**Economic and Social Council**Distr.: General
21 September 2021

World Forum for Harmonization of Vehicle Regulations**Working Party on Passive Safety Provisions****Seventieth session**

UN Regulation No. 129 (Enhanced Child Restraint Systems)**Proposal for Supplement 7 to the 03 series of amendments to
UN Regulation No. 129 (Enhanced Child Restraint Systems)****Submitted by the expert from the European Association of Automotive
Suppliers***

"Figure 1

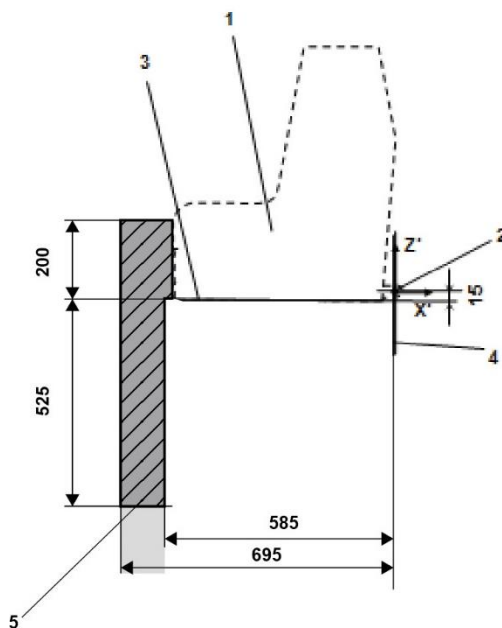
Annex 19., Figure 1, amend to read:

2. In our proposal, the top surface of the support leg volume has been raised upwards to match the support leg opening in the ISO/F2X envelope to facilitate more space for support legs. Increasing the height of the support leg volume would improve the compatibility between the support leg volume and the ISO envelopes. This would be particularly useful for large rearward facing CRS designs with support legs.

The support leg, including its attachment to the Enhanced child restraint systems and the support-leg foot shall lie completely within the support leg dimension assessment volume (see also figures 1 and 2 of annex 19 of this Regulation), which is defined as follows:

- (a) In width by two planes parallel to the X'-Z' plane separated by 200 mm, and centred around the origin; and
- (b) In length by two planes parallel to the Z'-Y' plane and positioned at distances of 585 mm and 695 mm forward of the origin along the X' axis; and
- (c) In height by a plane parallel to the X'-Y' plane, positioned at a distance of ~~70~~ **185** mm above the origin and measured perpendicular to the X'-Y' plane. Rigid, non-adjustable parts of the support leg shall not extend beyond a plane parallel to the X'-Y' plane, positioned at a distance of 285 mm below the origin and perpendicular to the X'-Y' plane.

The support-leg may protrude the support-leg dimension assessment volume, providing it remains within the volume of the relevant CRF."

"Figure 2

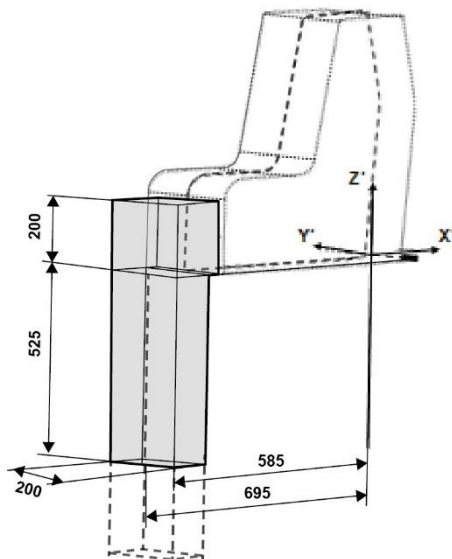
Annex 19., Figure 2, amend to read:

Figure

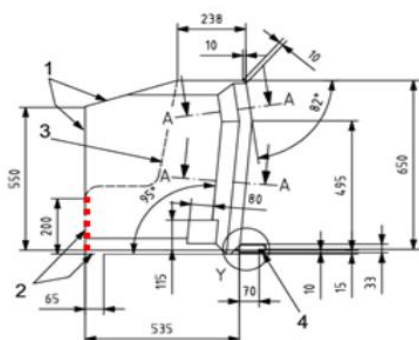
1. UN Regulation No. 16 defines the envelope dimensions of ISO/R2 and ISO/F2X CRF envelopes. The dashed line 2) represents the area where a support leg or similar may protrude. For the ISO/F2X envelope, this is indicated with a height of 200 mm.

4. The additional support leg volume already overlaps with the ISO/R2 volume and therefore little or no extra space is required (depending on ISOFIX position).
